REV.
C

AS3319

RATIONALE

STUD - STRAIGHT, RING LOCKED,
CRES AMS 5731
.190-24UNJC X .190-32UNJF

FIGURE 1 - STUD

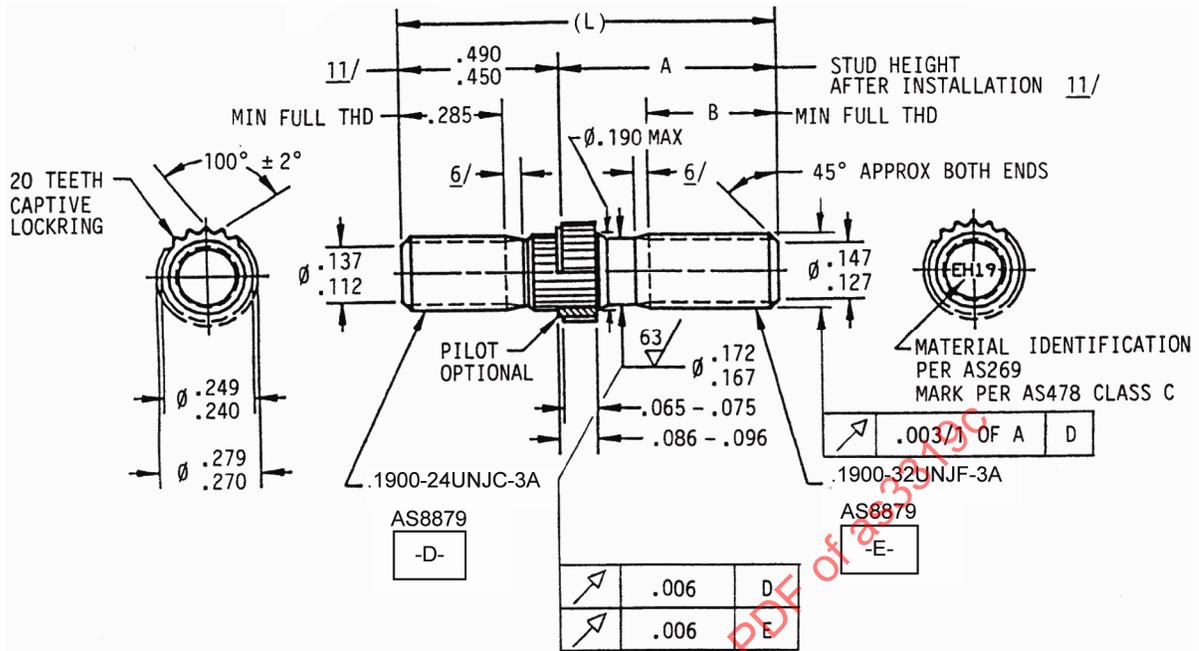
REVISE ROTATIONAL RESISTANCE VALUE.

- b. STUD SHALL PRODUCE A MINIMUM ROTATIONAL RESISTANCE VALUE OF 60 LBFxIN. TEST PROCEDURE PER NASM45909 AS APPLICABLE.
8. SURFACE TEXTURE: SYMBOLS PER ASME Y14.36; REQUIREMENTS PER ASME B46.1. UNLESS OTHERWISE SPECIFIED, SURFACES TO BE 125 μ in Ra, EXCEPT SERRATIONS TO BE 250 μ in Ra, AND THREAD FLANKS AND ROOT TO BE 32 μ in Ra.
